SUBJECT: NuScale Power, LLC Supplemental Response to NRC Request for Additional Information No. 433 (eRAI No. 9474) on the NuScale Design Certification Application

Response to Request for Additional Information Docket No. 52-048

eRAI No.: 9474

NRC Question No.: 06.02.06-22

Figure 1 Typical seal characteristic curve

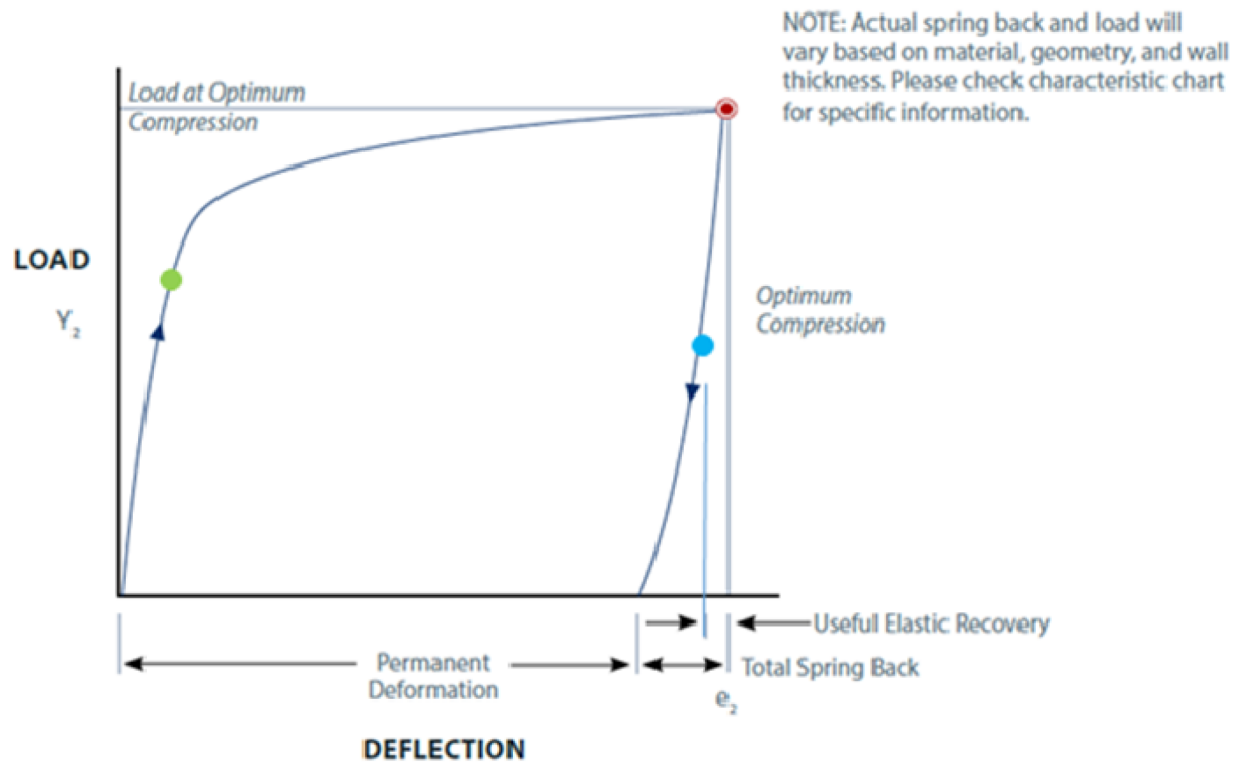
NuScale is requested to describe how the maximum allowable leak rate, L_a , will be demonstrated. Typically this would be shown through a combination of preoperational and periodic Types A, B and C testing. Since NuScale has requested an exemption from Appendix J Type A test requirements, this demonstration should include the technical basis for concluding that Types B and C testing are sufficiently representative of accident conditions to provide confidence that the test results from Types B and C assure that the assumed leak rate, L_a , would not be exceeded. Additionally, as required by 10 CFR 50, Appendix J, the acceptance criteria for Types B and C tests is to show that the expected leakage from all local penetrations, Types B and C, is less than $0.60 L_a$. This demonstration should consider the differences in test volume pressurization during Type A and Types B and C testing and their potential impact on the test results. For example, the stresses on a bolted connection would be significantly different during Type A testing, where the containment volume is held at accident pressure, than a Type B test, where only the volume between a double o-ring seal is pressurized.

Maintaining contact pressure, with reference to a typical seal characteristic curve (see Figure 1) ensures that the seals remain within their operating range established in their corresponding characteristic curves. As preload is applied the seal begins to compress to a point where the seal can accommodate minor changes due to pressure and temperature, which is indicated by the GREEN dot in Figure 1. The seal continues to be compressed until it reaches its optimal condition at the RED dot in Figure 1. When flanges are loaded by pressure inside of the vessel, decompression of the seal (spring back) may occur with prying and follow the down arrow line in Figure 1 below. The BLUE dot indicates the largest spring back the seal could incur and still expect to maintain the same seal as the optimal condition. When flange contact is maintained it is ensured that the seal configuration stays at the RED dot (optimal compression) in the figure and no practical decompression of the seal occurs. Since the seals for the CNV bolted flange connections are placed in a groove the seals are displacement controlled. So the transition from the GREEN dot to the RED dot will be very flat with very little additional load being applied to

seal as the stud preload is applied. At this time, the stud preload begins compressing the flange surface. The margin for the seal in this case is the full useful elastic recovery of the seal.
